STAFF REPORT
(Preliminary Plat)

CASE NUMBER: SUB 2005-148 -- BELLECHASE ADDITION

**BELLECHASE ADDITION
WICHITA, SEDGWICK COUNTY, KANSAS
DRAINAGE ANALYSIS
MAY 2006**

I have reviewed **Belle Chase** drainage plan that was submitted on February 7, 2006 and have the following comments:

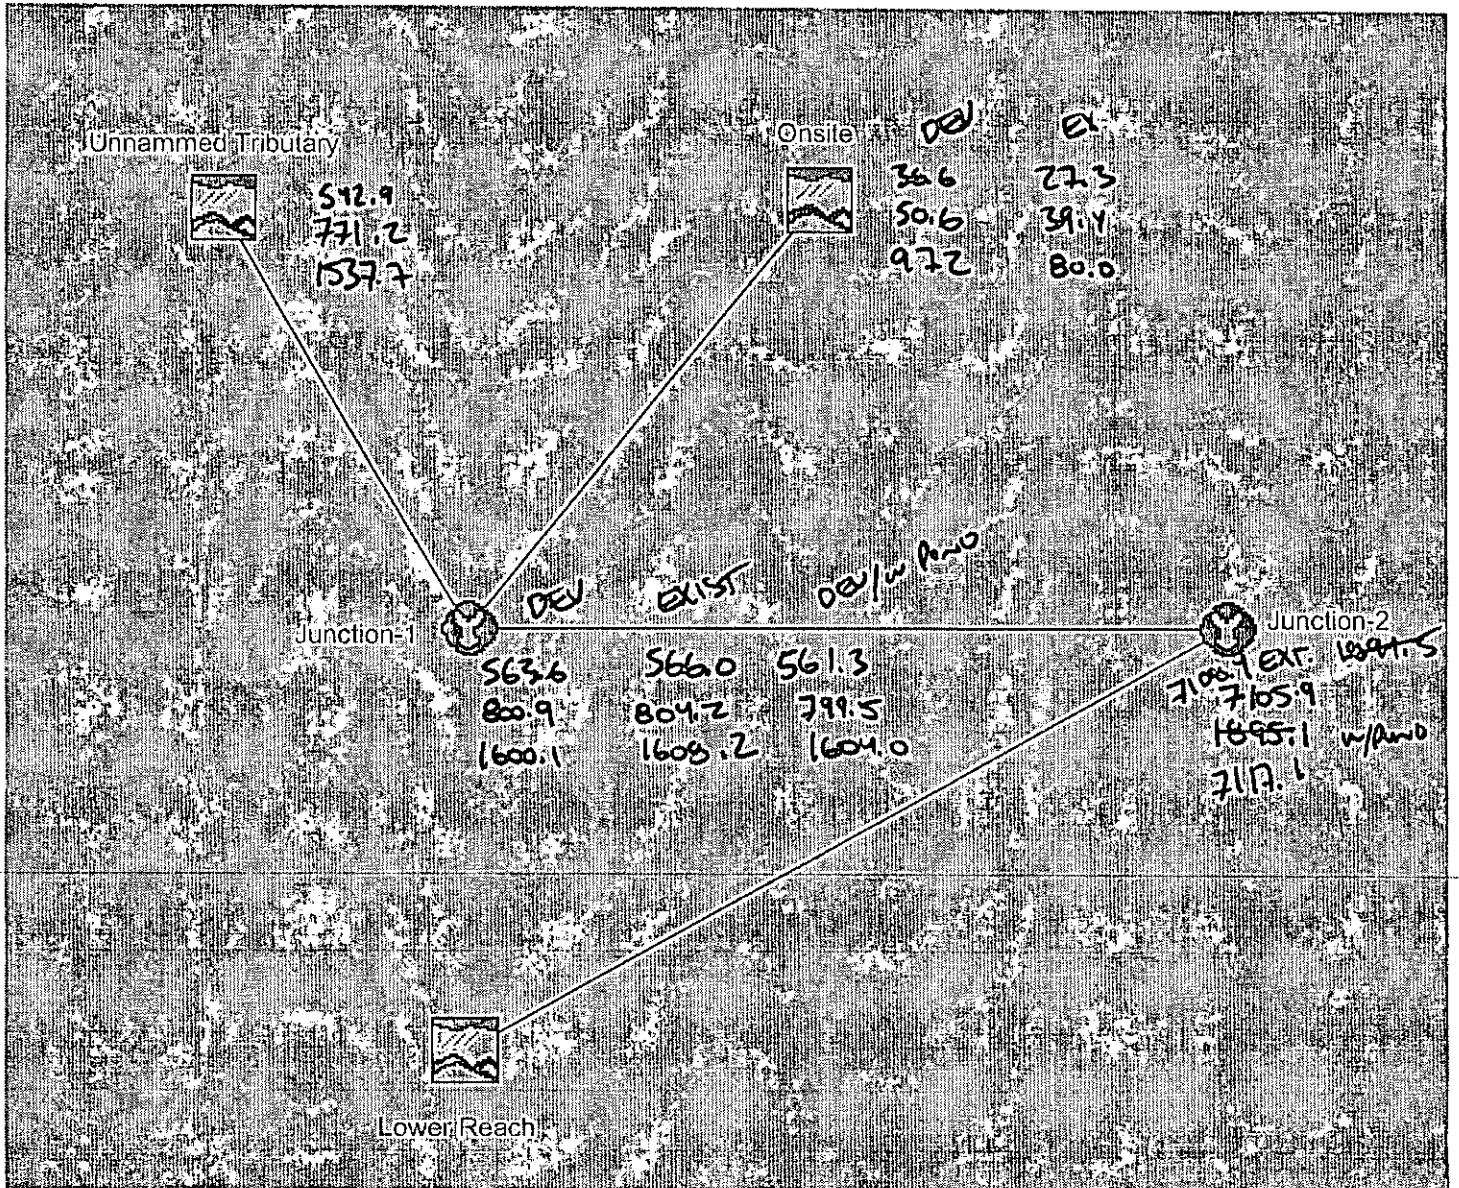
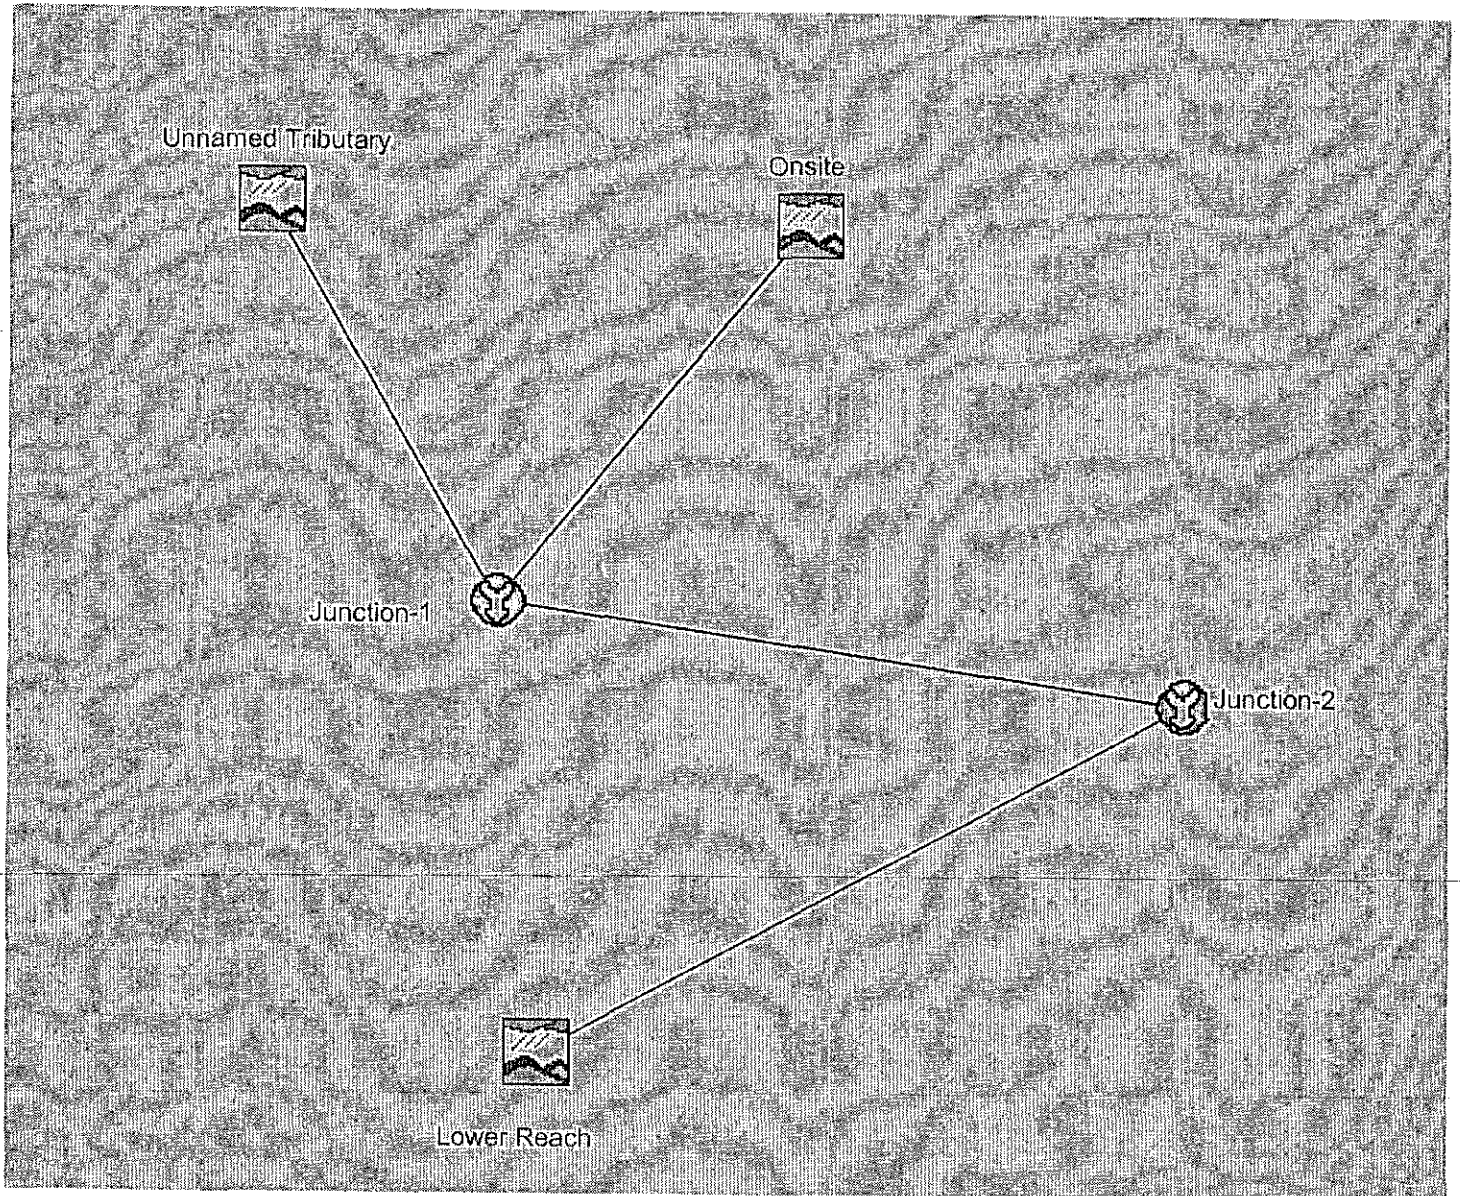
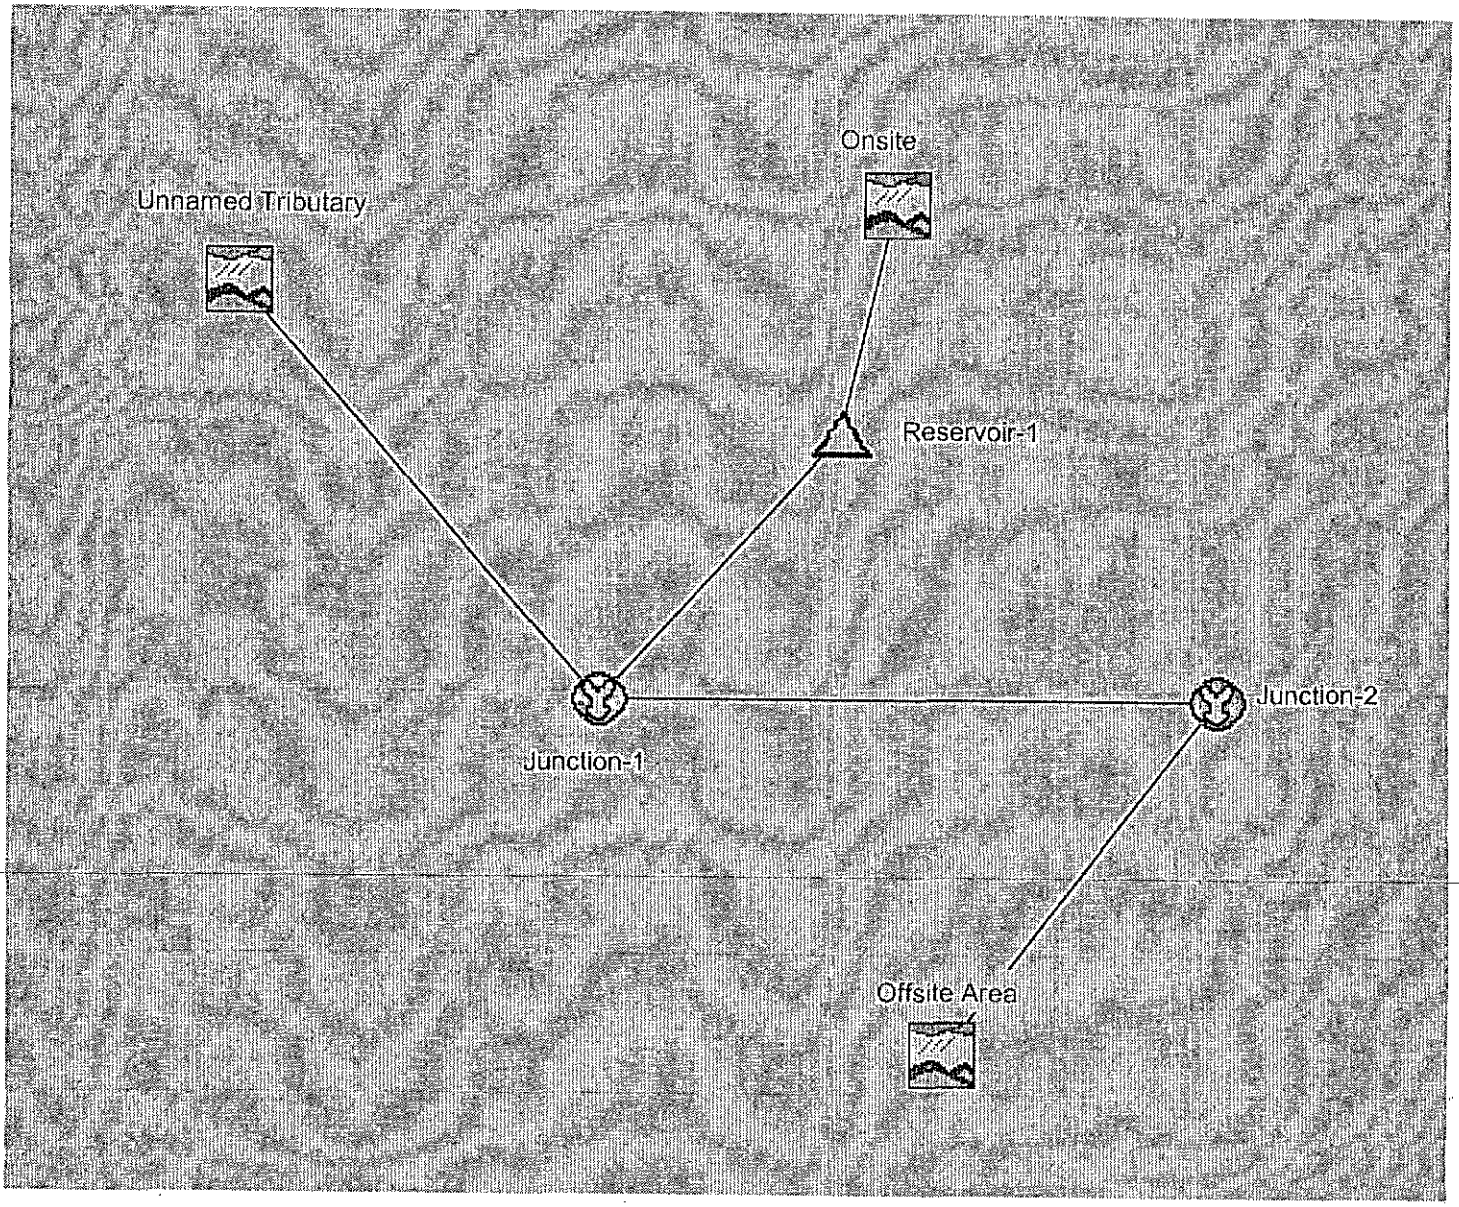
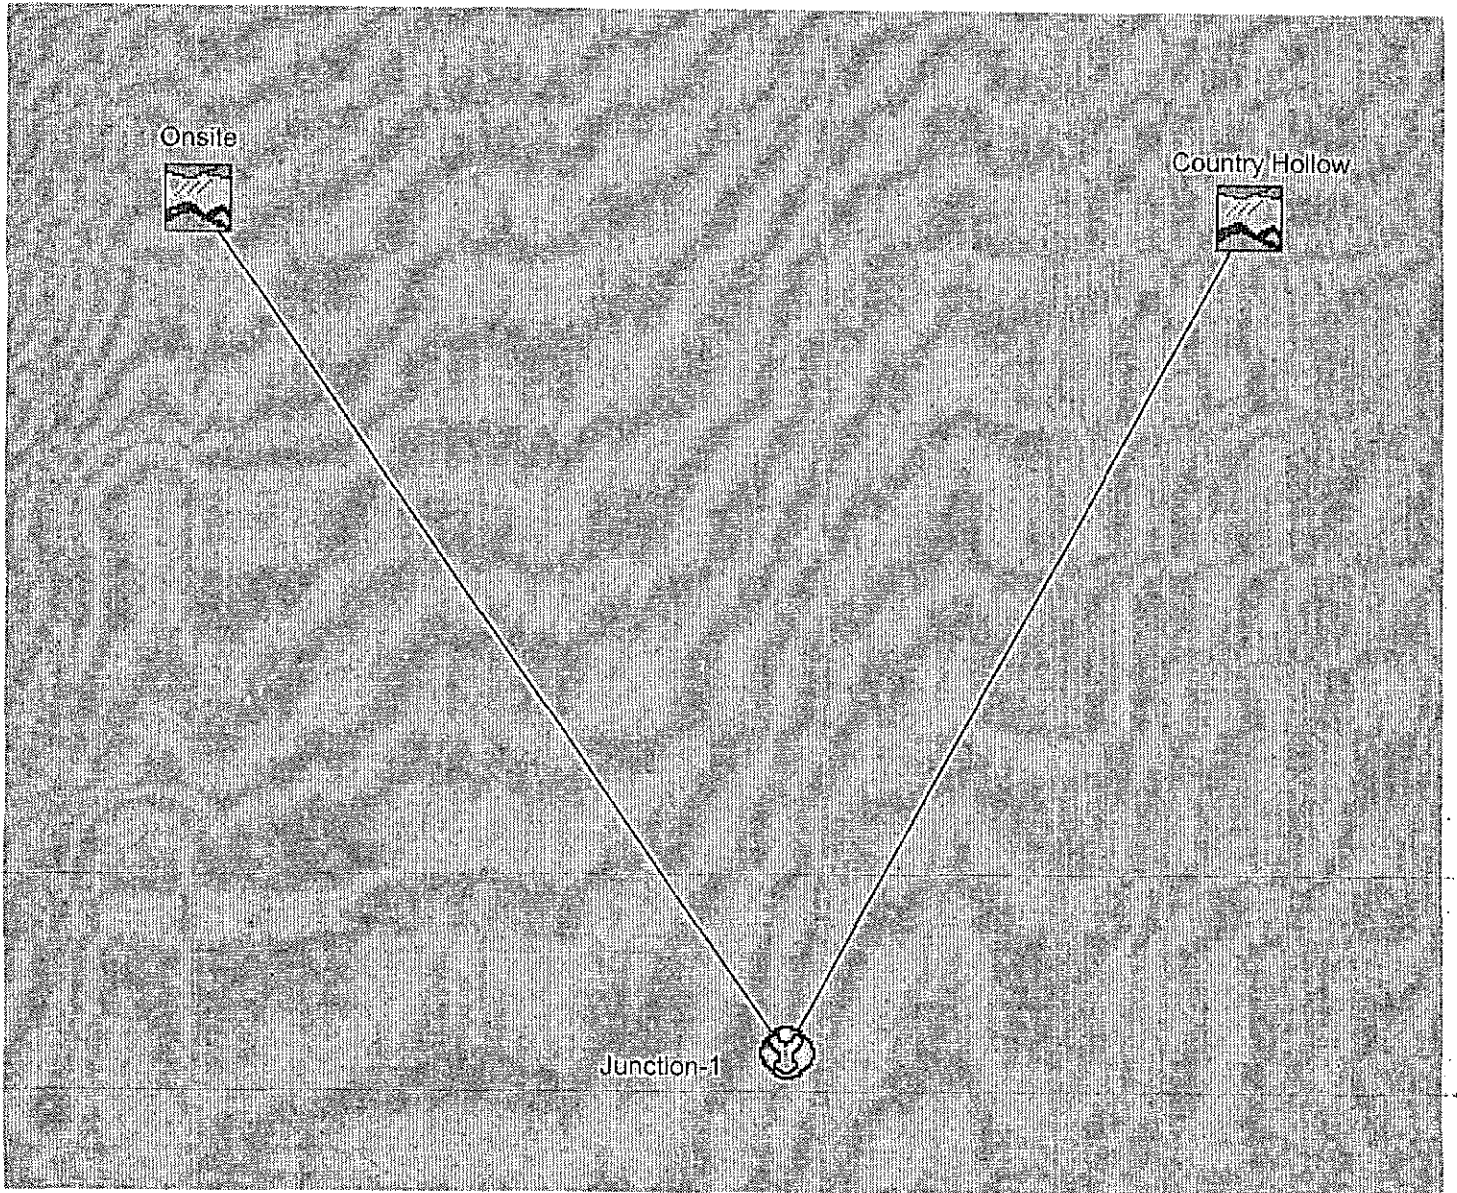
Please look at the minor storm event.

5. The peak flow rates for the minor storms should be evaluated in the drainage report, in addition to the 100-year event.

An evaluation of the 2 year storm shows the onsite runoff increasing from 27.3 cfs to 36.6 cfs. However, due to the differences in time of concentration between the large basin and the small basin, the combined flow for the channel doesn't change. Attached are the flow summaries for the predeveloped and developed basins. Also included is a comparison that includes the Country Hollow diversion. It shows a predeveloped combined flow of 46.4 cfs from Bellechase and Country Hollow Addition compared to a post-developed flow of 36.6 cfs from Bellechase. By both measurements, detention should not be required for Bellechase.

Flow rates for both the two year and one hundred storm are calculated for the storm water sewer sizing. The two, five, and 100 year basin runoff calculations are now included in the plan. Since each of the interior storm water sewer systems is designed for the 100 year event, the two year event is more than satisfied.[Lindebak, Scott]

Attached are the HEC-HMS runs for the pre and post developed storm events.
